# 3 STRATEGIC DIRECTION

Hearing of Submissions on Proposed District Plan  
Report 3  
Report and Recommendations of Independent Commissioners Regarding  
Chapter 3, Chapter 4 and Chapter 6

Figure 33-1: C Barr, Flow Diagram

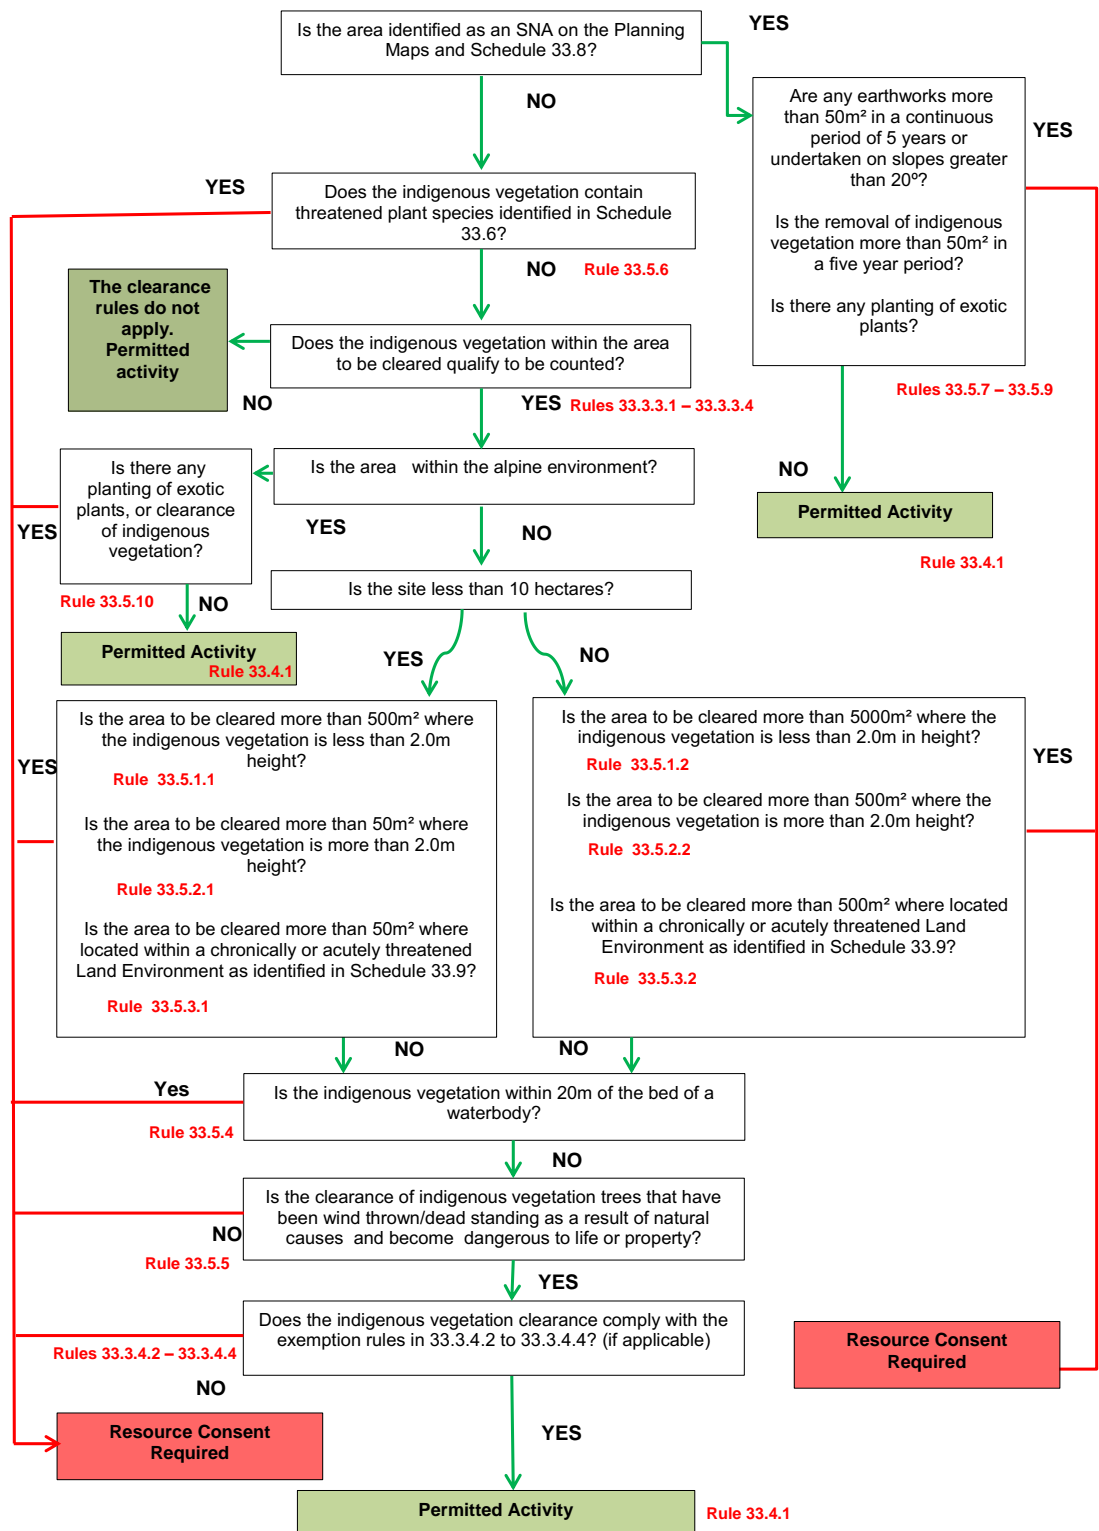
1382. We state at the outset that we found the provisions, other than those relating to SNAs and land over 1070 masl to be confusing and difficult to use to the point of almost being incomprehensible. Thus, we did not consider they accorded with Policy 33.2.1.3, which sought to provide standards that were practical to apply.

1383. In an attempt to understand how the Council envisaged these provisions being applied we asked Mr Barr to prepare a flow diagram of how the rules were to be applied, and to provide photographic examples of land containing indigenous vegetation along with an explanation of how the rules would apply to that land. We thank Mr Barr for the effort he put into answering these requests, and note that his examples assisted us greatly in our deliberations.

1384. We include final version of Mr Barr's flow diagram as Figure 33-1.

Figure 7: Extension to Cardrona SASZ sought by Soho

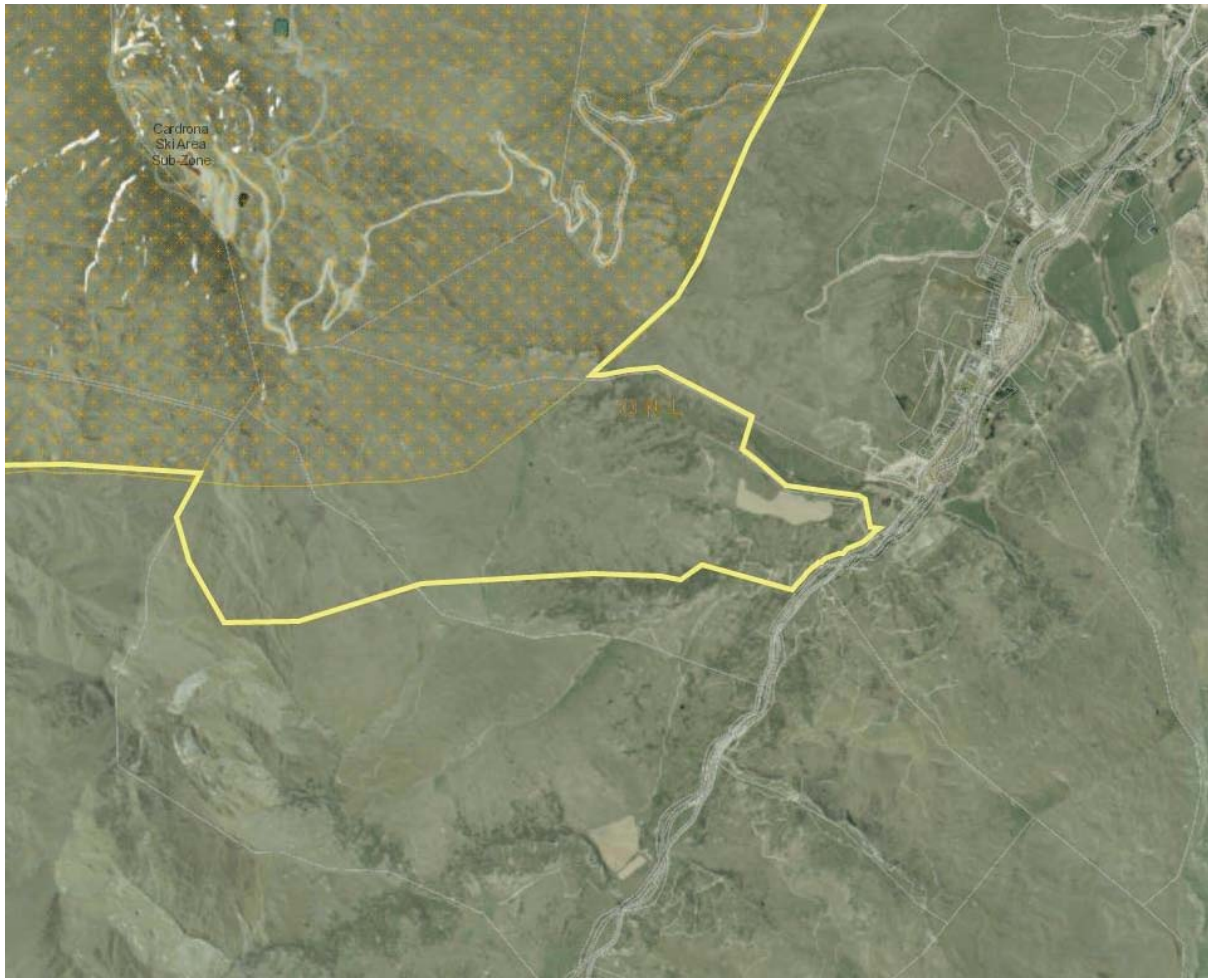
## 7. SOHO – SUBMISSION 610

Figure 8: Amended extension presented by Mr Ferguson for Soho

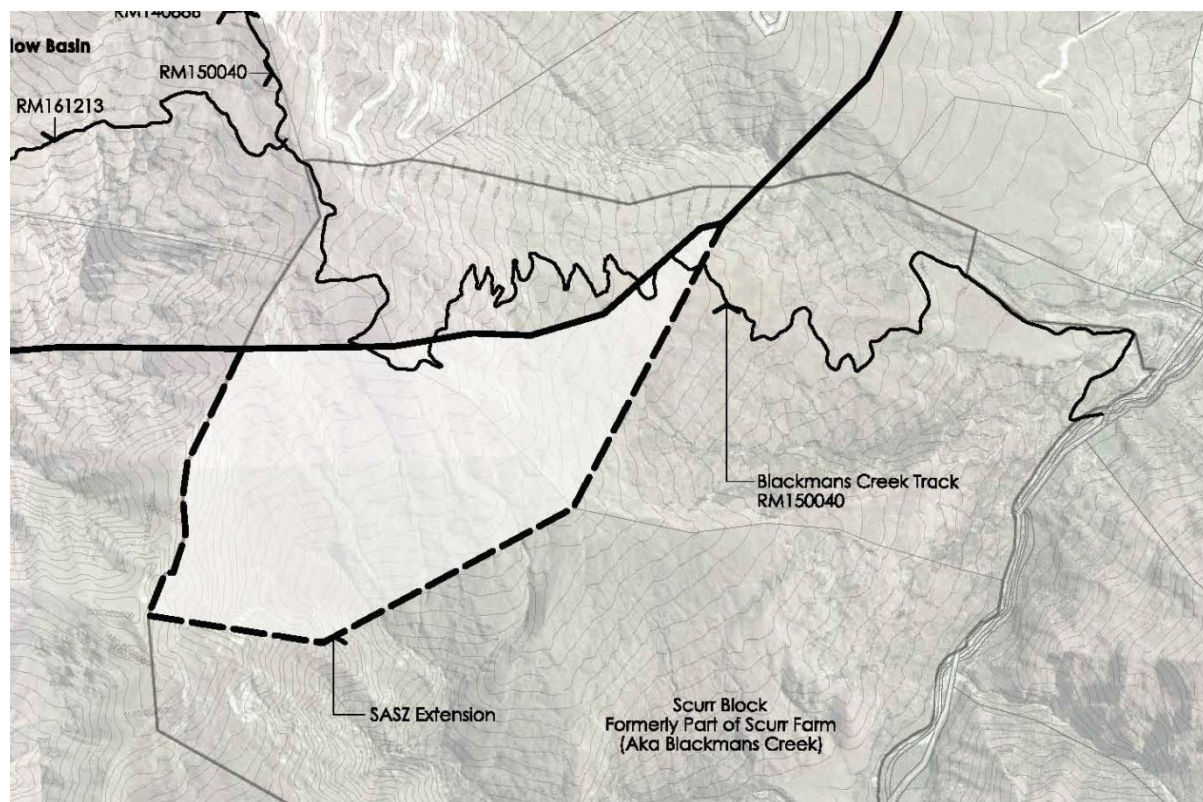
158. At the hearing Soho, via legal submissions of Ms Baker- Galloway and evidence of Mr Ferguson, reduced the extent of rezoning to the upper reaches of the Callaghans Creek and Blackmans Creek Basin (mostly above the snow line at 1100masl). The reason given for this was to provide opportunity for skiing. The reduced area is as shown below in Figure 8. This report only addresses the reduced area sought by Soho.

160. As shown Figure 8, the area sought to be extended has been significantly reduced, and now seeks an extension to the SASZ at the higher elevations. A part of the 'reduced area' shown above is beyond that which was requested in the original submission. This was acknowledged by Ms Baker- Galloway in her legal submissions<sup>39</sup> where she stated.

Figure 9: Cardrona SASZ as recommended.

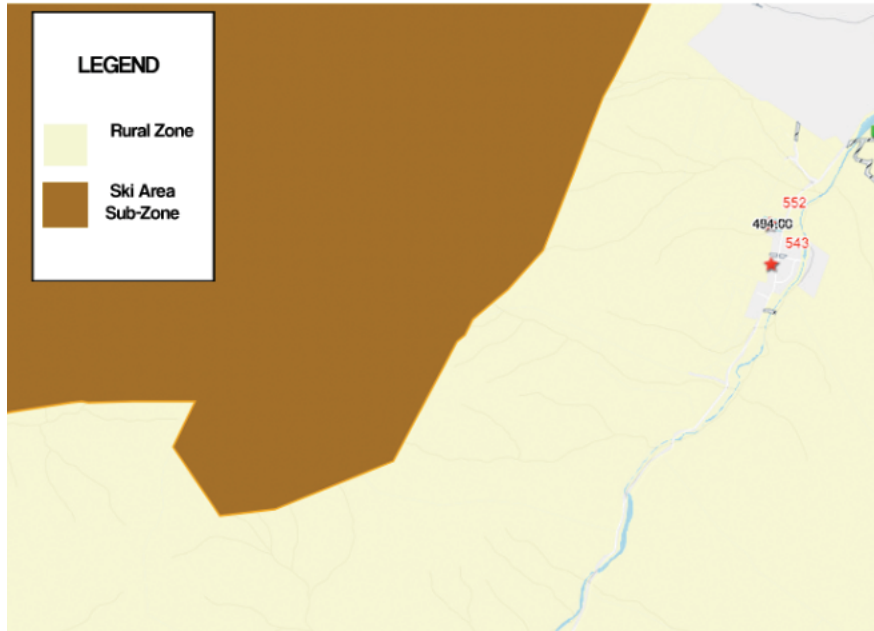
- a. Accepting the revised (reduced SASZ within scope) proposed rezoning of Soho (610) as shown in Figure 9 below;
- b. Accepting in part the further submission of Queenstown Park Ltd (FS 1097); and
- c. Accepting in part the further submission of MCSL (FS 1153).
